Re: 49 CFR Part 573; Recall of Mercedes-Benz vehicles to replace Power Steering Hose and clamp

RE: Recall Campaign 2003040005 - Replace Power Steering Hose and Clamp Due to Possible Fluid Loss at Radiator, Model 163, Model Years 1998 - 2004 Revision D

Campaign No. 2003040005, October 2008

Replace Power Steering Hose and Hose Clamp

Figure 1

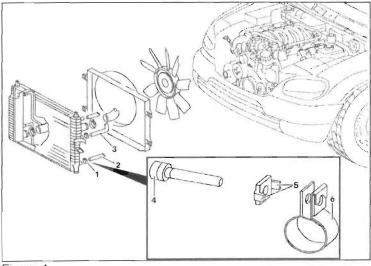
Revision d of this Recall Campaign involves replacement of the low pressure power steering hose and clamp (1 and 2, Figure 1) on certain vehicles that were previously repaired without the latest repair kit. MBUSA has determined that, on certain vehicles, the repairs previously conducted under this recall may have been performed with a method that makes it susceptible to future power steering fluid leaks or disconnection of the low pressure power steering hose. Vehicles repaired without the latest repair method will be repaired again. These vehicles will be repaired with the latest service instructions and with a parts kit that was designed to eliminate the potential for future leakage. This action involves approximately 111,382 vehicles that were part of the earlier recall of approximately 225,901 vehicles. MBUSA will also be mailing a version of this notice to the approximately 9,521 owners who have not responded to the 2003 owner notification. In addition, based on our latest review of warranty data and current vehicle registrations. MBUSA will be mailing notifications to 4,323 MY 2003 - 2004 owners who were not included in the initial 2003 campaign. Dealers will replace the lower power steering hose and clamp in all affected subject vehicles.

11. Slide the installed new hose clamp toward the radiator and locate in the proper position on the low pressure power steering hose (1, Figure 1) as shown and tighten hose clamp screw (6, Figure 2).

- Observe tightening torque of: Nm 2.0 + .5 / 0.0 and proper orientation of the anti-rotation tabs (5, Figure 1).
- Ensure that only the low pressure power steering hose clamp, as supplied in the repair kit, is used during the reinstallation of the low pressure power steering hose.

Figure 2 (sealing ring vehicle shown, vehicles with flare fitting and O-ring may be different)

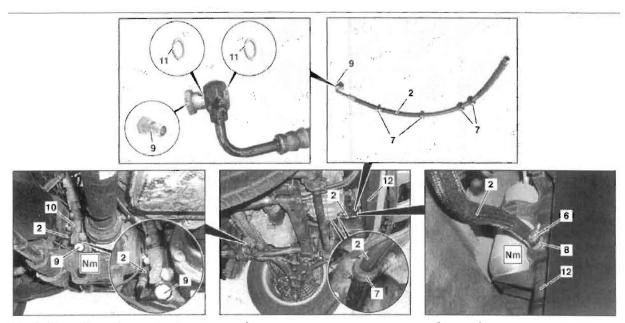
- 6. Detach low pressure power steering hose mounting grommets (7, Figure 2) from 4 holders (attached to the frame rail on the left front of vehicle).
- 7. Loosen hose clamp (6, Figure 2) and disconnect low pressure power steering hose (2) from radiator fitting.
- 8. Remove banjo bolt (9, Figure 2) securing low pressure power steering hose (2) to power steering rack (10) and remove low pressure power steering hose by routing out towards rear of vehicle.

- Carefully clean low pressure power steering hose connection (8, Figure 2) at the radiator, using a lint-free shop towel to ensure that no power steering fluid residue is present on the hose connection. Install the low pressure power steering hose DRY onto the hose connection (8, Figure 2) at the radiator (12, Figure 2)
- Do not use any cleaning agents.
- 9. Install new low pressure power steering hose (2, Figure 1) in reverse order (use new hose clamp, as provided in the repair kit).

Install new sealing rings (11, Figure 2) or rubber O-rings as applicable when installing new low pressure power steering hose (2).

As equipped: torque banjo bolt to 30 Nm or flare fitting with O-ring to 30 Nm, see WIS document: AR46.20-P-0600GH.
